BISON BASIN PROJECT

DEQ PERMIT TO MINE NO. 504

PROPOSED MODIFICATION

JULY 14, 1981

Fig. 2.2. Bison Basin Project mining plan. For a detailed view of first mining unit, see Fig. 2.3. Source: ER, Fig. 3.2-1.

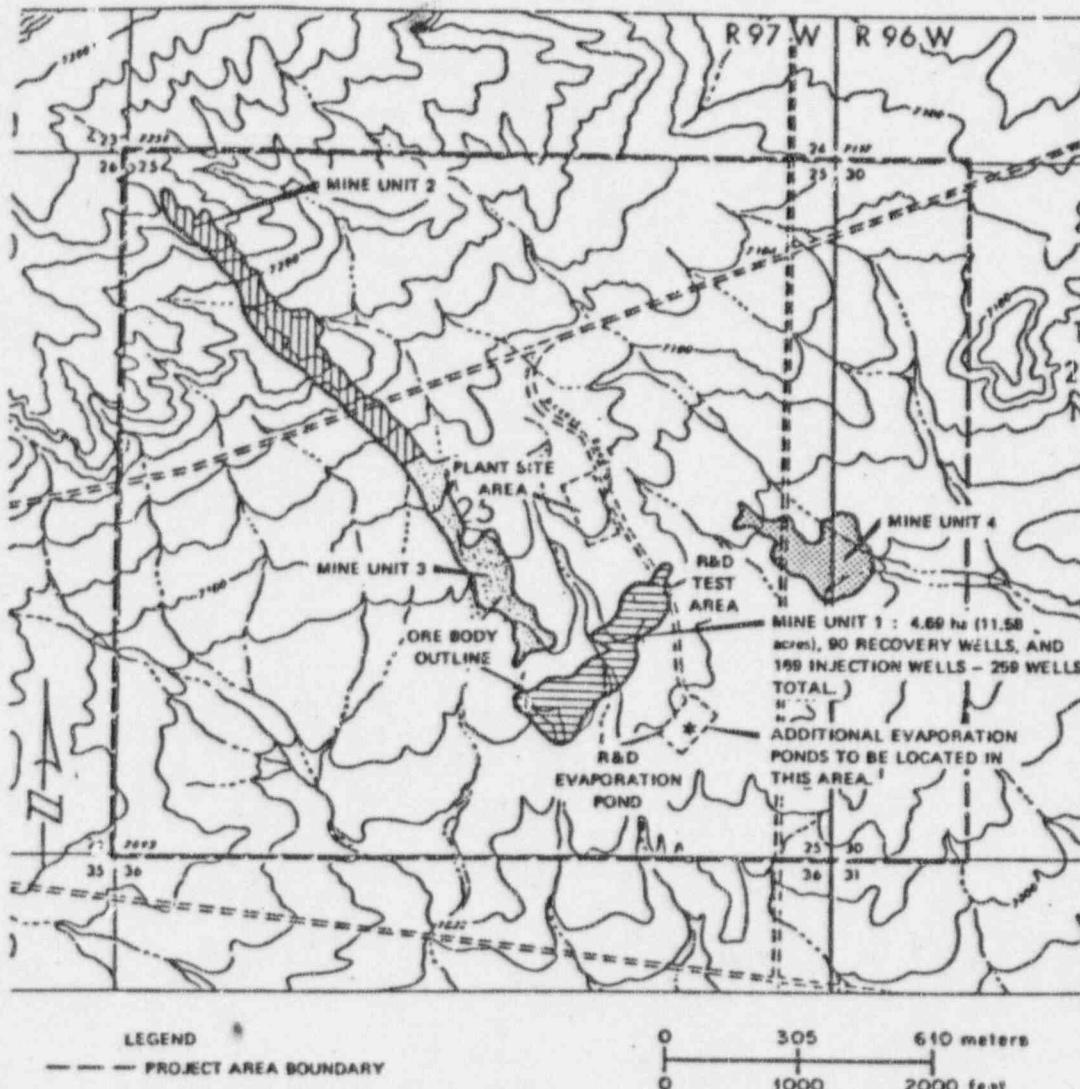
The mine plan submitted with the initial application partitioned the approximate 40 acre orebody into four units as depicted in the FES (Docket No. 40-8745), Figure 2.2, page 2-25 (see attachment 1). The four units were to be mined in the sequence shown in attachment 1.

The revised mine plan, based on the orebody outline presented in attachment 2 is shown on a map included with this document and identified as attachment 3. The mining sequence will be mining unit No. 1, mining unit No. 2 and mining unit No. 3. The surface areas of these three units are 29 acres, 25 acres and 21 acres; respectfully.

Fig. 3.9. Location of faults (f) transecting the ore body. Geologic section of C-C' will be presented in Fig. 3.16, F-F' in Fig. 3.17, and G-G' in Fig. 3.18. Source: ER, Fig. 2.4-3.

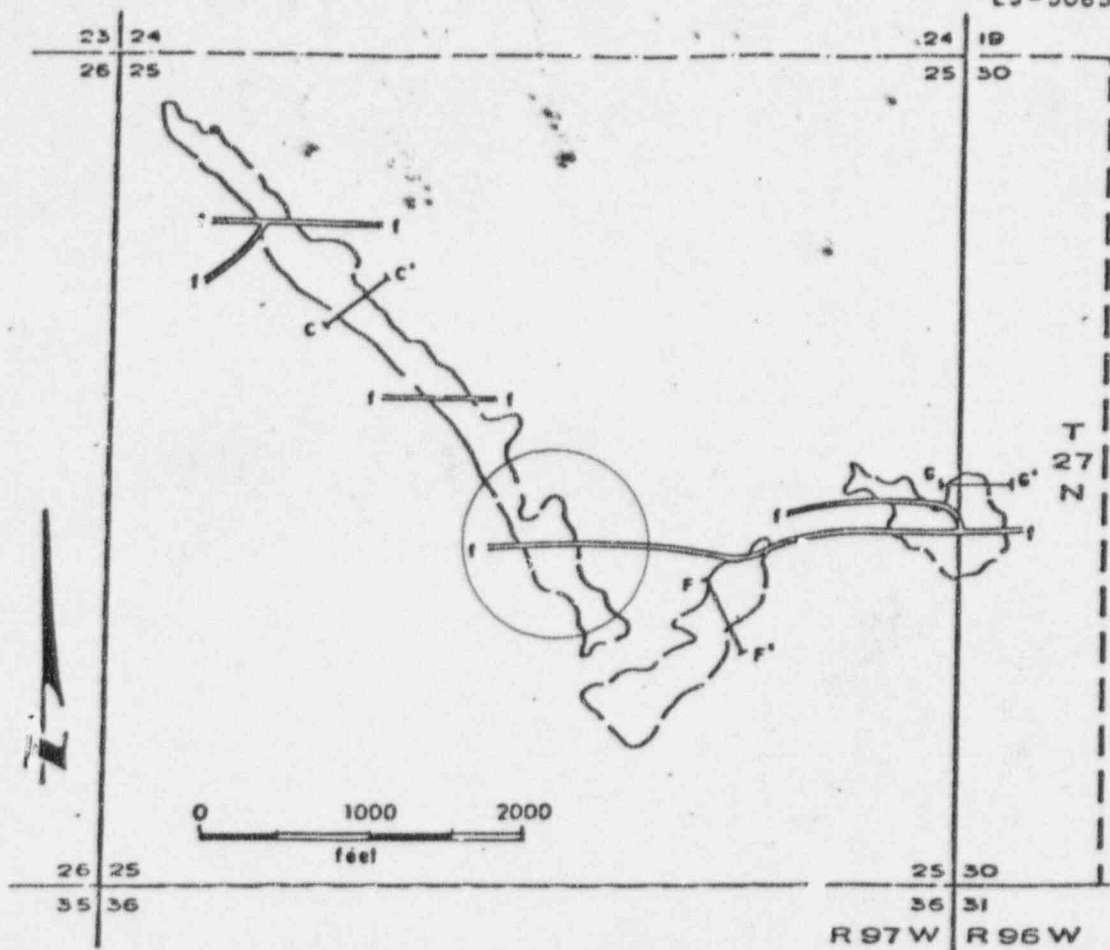
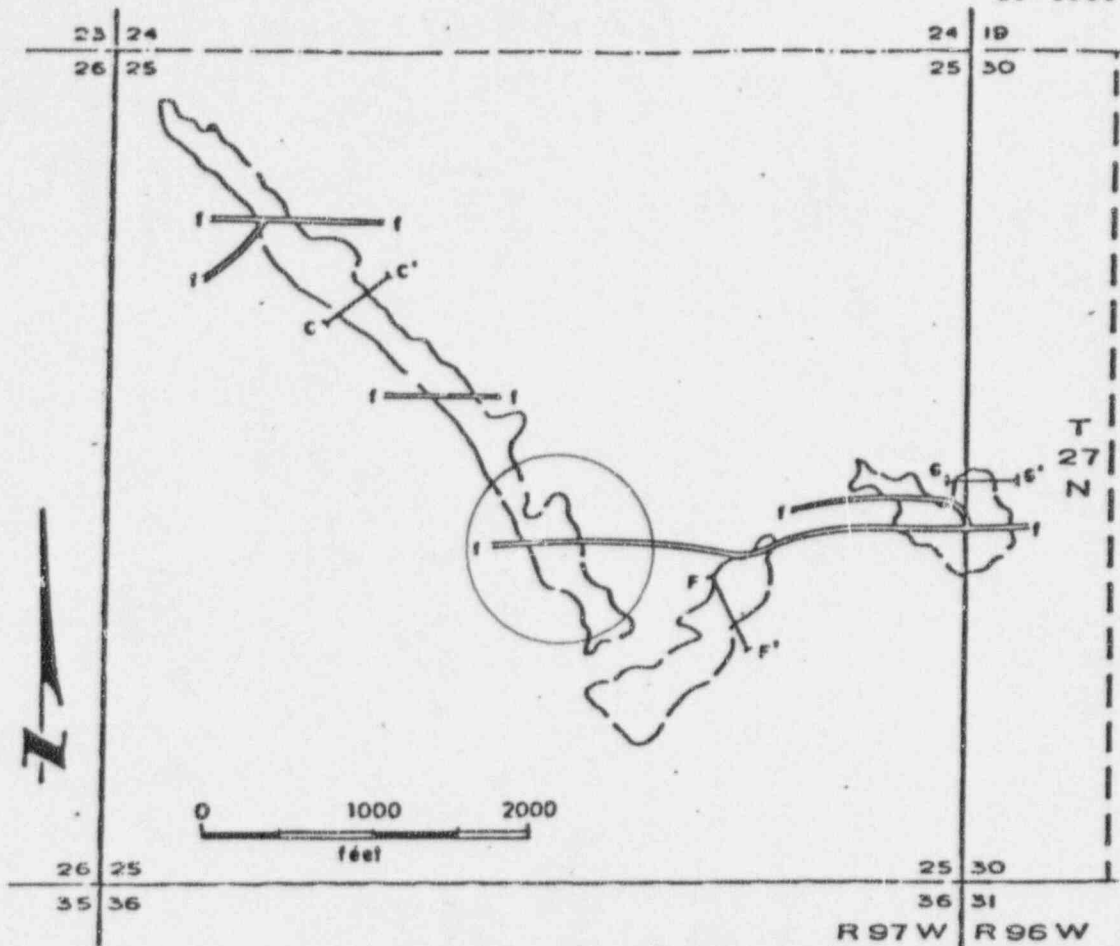
The additional hydrogeologic testing required outside of the original mining unit No. 1 specified in the DEQ permit application (page 179 A) and the NRC source material license will be performed in the new portion of the mining unit No. 1 near the fault shown in Figure 3.9 (page 3-25) of the FES and also shown in Figure 8-14 (page 48) of the DEQ application. A copy of Figure 3.9 is included with this report as attachment 4, with the above mentioned fault circled in red.
